DIABLO CANYON
INDEPENDENT SAFETY COMMITTEE (“DCISC”)
(www.dcisc.org)

PUBLIC MEETING AGENDA

Following issuance of evaluations performed for the DCISC of public concerns regarding Diablo Canyon Unit 1 [Part 1 Report] and of PG&E's embrittlement forecasts for that plant [Part 2 Report], the DCISC invited members of the public to comment on those reports. This document provides my replies to comments provided by Mr. Bruce Severance to the DCISC in his document titled, "Is DCP Unit 1 Reactor a 'Good Bet' for the People of California?" dated 15 April 2024. I have marked Mr. Severance's document:

Part 2 Report, Figure 4. Comparison of consultant's ART estimates (curves) with those of PG&E (diamonds) for the timeframe 2003-2011 [Diablo LRA 2009] and 2011-today [WCAP-17315]. The NRC's required process for adjusting data is described in the Part 1 report, Section 2.4.2.2.

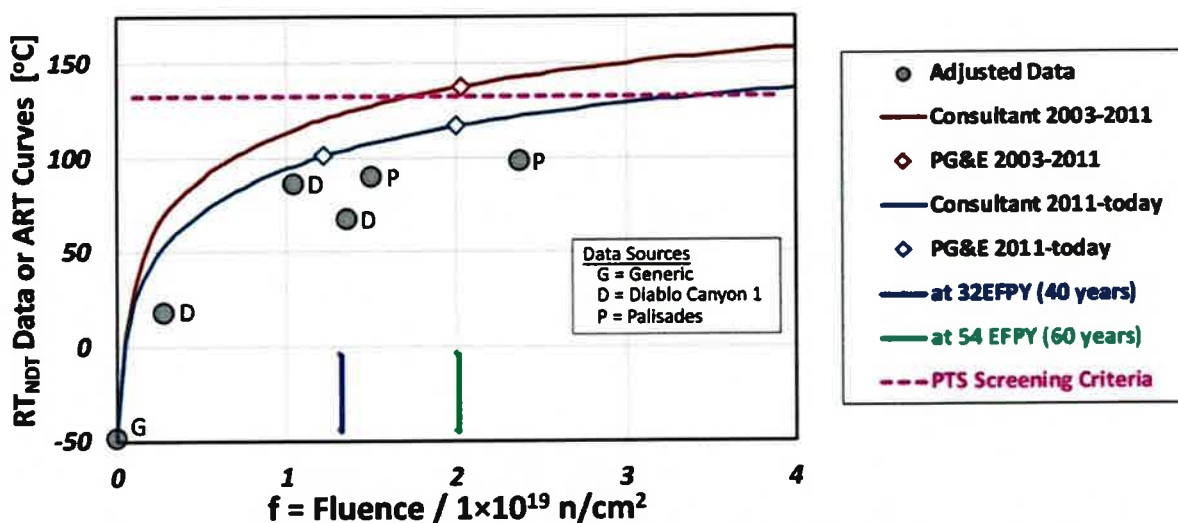
Comment "The pre-2004 test data and PG&E's own 2006 calculations indicate this embrittlement will be reaching the Federal Code of Regulation "screening limits" [on pressurized thermal shock as expressed in 10 CFR 50.61]¹ by 2025 (also confirmed by NRC in 2006)"

Reply The statement that, based on data available before 2004, Diablo Canyon Unit 1 was forecast to exceed the PTS screening criteria in 2025 is incorrect. This information does not agree with that submitted by PG&E as part of its 2009 license renewal application [Diablo2009 LRA], which was based on the pre-2004 surveillance capsule data from Diablo Canyon Unit 1 cited in this comment. [Diablo2009 LRA] provided the following information.

Figure 4 of the Part 2 report, which is copied below for convenience, validated this RT_{PTS} estimate to within 1 °C. The dark red curve on Figure 4 shows this estimate of RT_{PTS} to be below the PTS screening criteria (270 °F or 132.2 °C) at the 32 EFPY fluence but above the screening criteria at the 54 EFPY fluence. The information from Figure 4 was used to determine that, using only information available before 2009, the PTS screening criteria was then forecast to be exceeded at a fluence of $1.8 \times 10^{19} \text{ n/cm}^2$, which would occur at approximately 46 EFPY. However, in 2025 refueling outage Diablo Canyon Unit 1 is currently forecast to reach 35.2 EFPY. Thus, the statement

in the comment that, based on data available before 2004, Diablo Canyon Unit 1 was forecast to exceed the PTS screening criteria in 2025 is incorrect.

It should also be pointed out that the 2006 RT_{PTS} estimates cited by this comment are no longer current. Since 2011 additional information on the limiting weld (weld wire heat 27204) has been available in the form of two ΔT_{41J} measurements made by the Diablo Canyon's "sister plant" Palisades [WCAP-17315]. When incorporated into the PTS analysis, as required by the NRC, those data demonstrate that Diablo Canyon Unit 1 will not exceed the 10 CFR 50.61 screening criteria until long after 60 years of operation (see blue curve on the Part 2 report, Figure 4, which is copied below). The Part 2 report validated the [WCAP-17315] evaluation Diablo Canyon Unit 1 surveillance data as augmented by the sister plant data from Palisades (also see the figure).
